NONMANDATORY APPENDIX G FRACTURE TOUGHNESS CRITERIA FOR PROTECTION AGAINST FAILURE

It is proposed to add the following paragraph. This paragraph is an alternative risk-informed procedure to the current Paragraph G-2215, which provides a deterministic procedure to determine the allowable pressure temperature curves for Level A and Level B Service Limits. The following paragraph essentially duplicates G-2215 except it uses risk adjusted margins instead of deterministic margins as shown by “Track Changes”.

G-2216 Risk-informed Allowable Pressure

Fig. G-2216-1

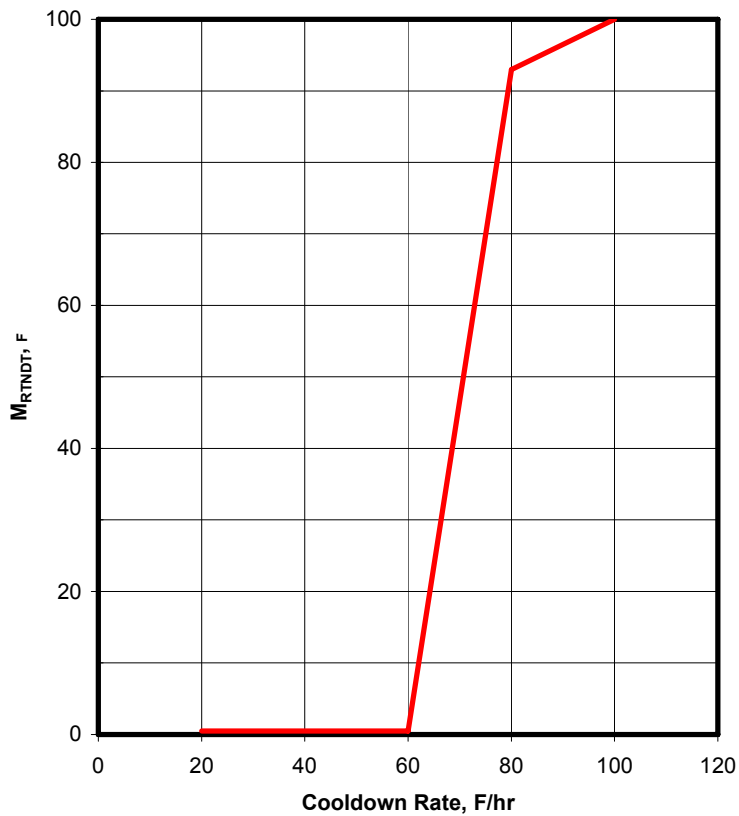
M_{RTNDT} is a risk adjusted factor applied to K_{IC} and is determined from Fig. G-2216-1.

$$RT_{\text{NDT}} = RT_{\text{NDT}(u)} + \Delta RT_{\text{NDT}} + M_{\text{RTNDT}},$$
